THE CITY OF DURHAM TRUST

DM/21/02360/FPA: Sniperley Park

The City of Durham Trust is grateful for the opportunity to comment on the revisions to this application, made available on 27 January. This letter also responds to the Transport Assessment (made public on 3 December 2020) and replaces the Trust's letter of 10 October relating to the transport aspects of the application.

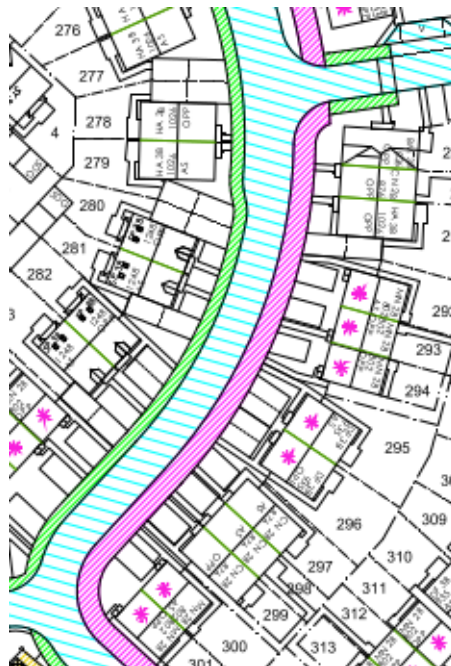
Cycleways are shown in pink. This short cycleway link meets the main access road but does not connect across the verge to allow people to join the cycleway on the other side.

Pavements are shown in green (see excerpt below). Each cul-de-sac has the pavement stopping well before the end of the road. It is likely that it is the type of design where the carriageway comes up to the same level as the footway to provide a shared space at the end of the road. A change of surface would be preferable so that drivers have a clear signal that the space is different.

Note the sinuous footpath that skirts the site. From many cul-de-sacs there is no formal connection to the footpath shown. People will inevitably create a path by walking across the grass, but there should be a properly designed connection to ensure wheelchair accessibility.

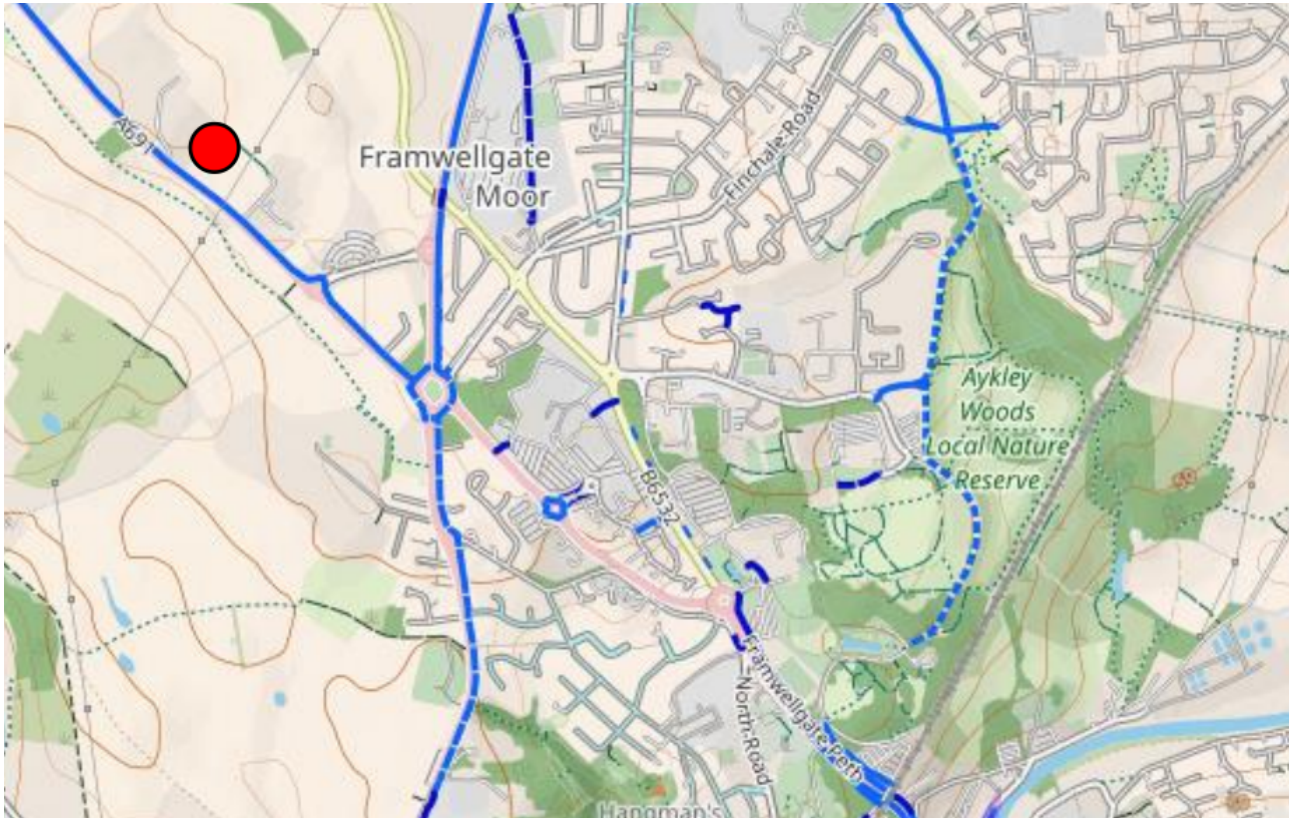
If you apply the LTN 1/20 junction assessment tool to the junctions in the area, and to the new roundabout junction proposed for access to the site from the A691, all of the potential cycle movements that cross arms of the roundabouts would achieve a score of zero. CD195 Designing for Cycling Traffic, which is part of the Design Manual for Roads and Bridges, requires grade separation or signal-controlled crossings where cycle routes cross high flow 40mph roads or 2-lane roundabout entries within a 30mph limit.
